# SERVICE BULLETIN #1108

SUBJECT NEW STARTER ASSEMBLY - P/N 57117A

MODEL 1-41, 1-51, MC-6, and MC-10 DATE 10/17/60

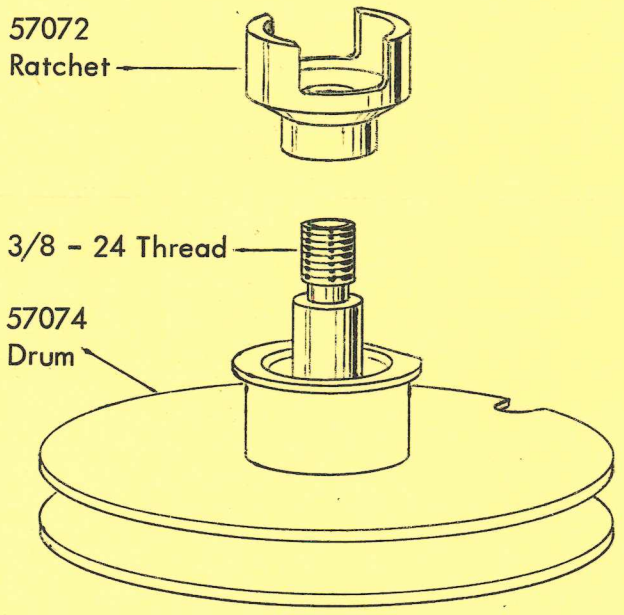
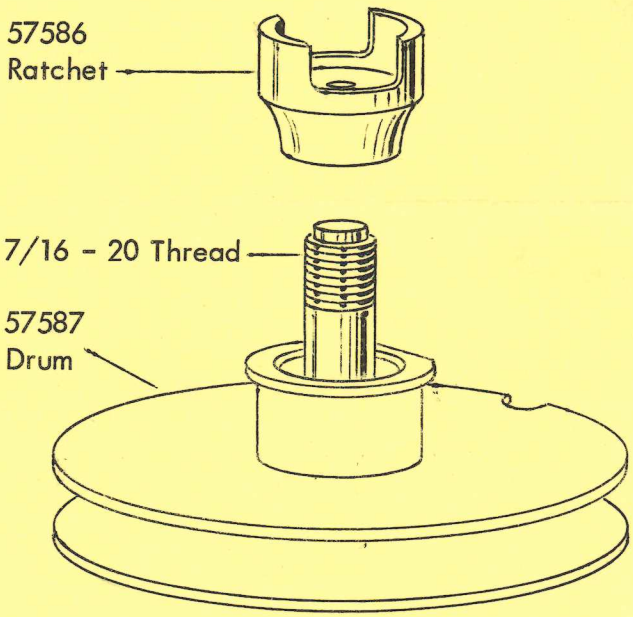
An improved Starter Assembly, P/N 57117A, is available for service replacement on Model 1-41 and 1-51 chain saw engines and MC-6 and MC-10 kart engines which have starter kits installed. The new Starter Assembly contains a redesigned Starter Drum and Starter Ratchet which increase service life and provide easier disassembly when service replacement is necessary (see illustration below).

When replacing a 57074 starter drum, also replace the 57072 ratchet; and conversely, when replacing the 57072 ratchet, replace the 57074 starter drum. Thread sizes of the new and the replaced parts are different and therefore they cannot be interchanged separately.
